ADDENDUM NO. 1
TO
CITY OF AUBURN, MAINE
2026 ALLIED ROAD RECLAMATION PROJECT BID#2026-011
DATE: 1/23/2026

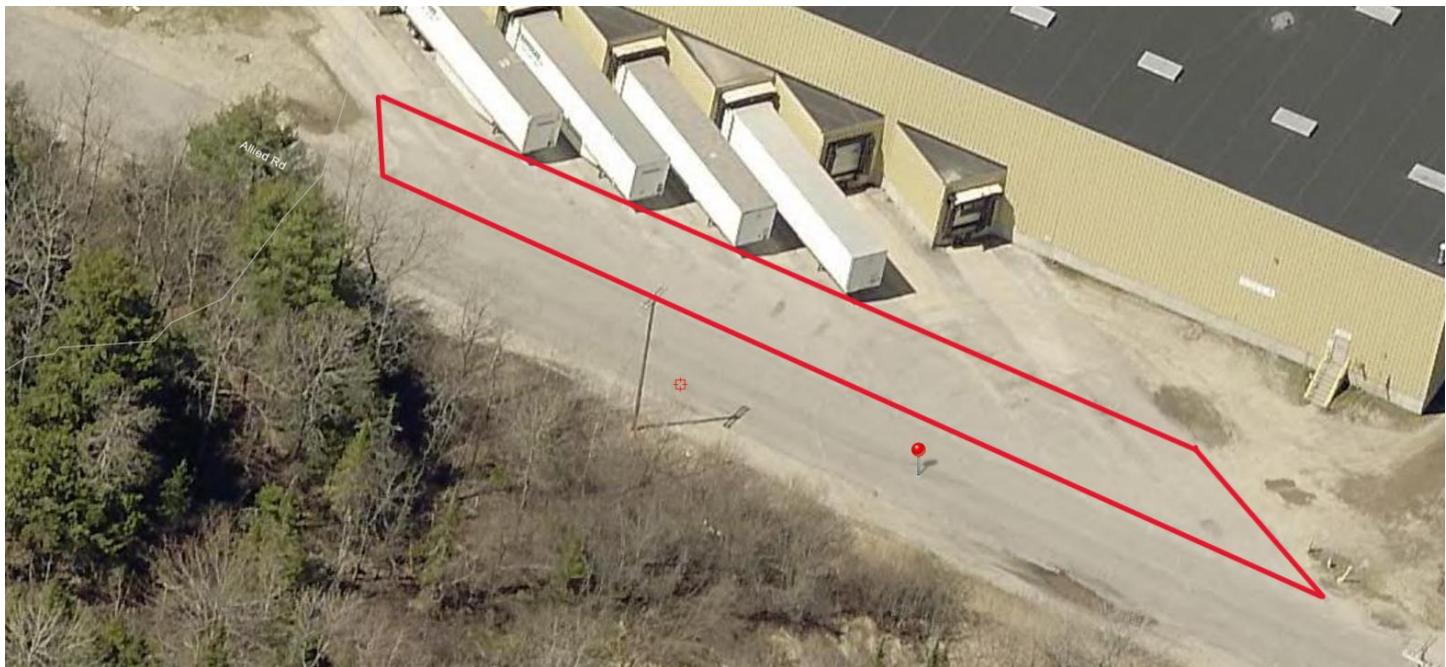
Q: **"Special Paving Areas": Can you please clarify whether the grinding and paving is intended to include the entire area surrounding the concrete, including the pavement between the concrete pads, or if the existing pavement in that area is to remain as is?**

Q: **Can you identify the location, size and thickness of item 403.102 Hot Mix Asphalt – Special Areas?**

A: Saw cut along the front corners of the concrete pads rather than grind. The paving does not include between the pads just from the saw cut to the road edge. Picture below;

A: Picture above shows location. The buildup will be 2" of 19mm HMA Base and 1.5" of 12.5mm HMA Surface.
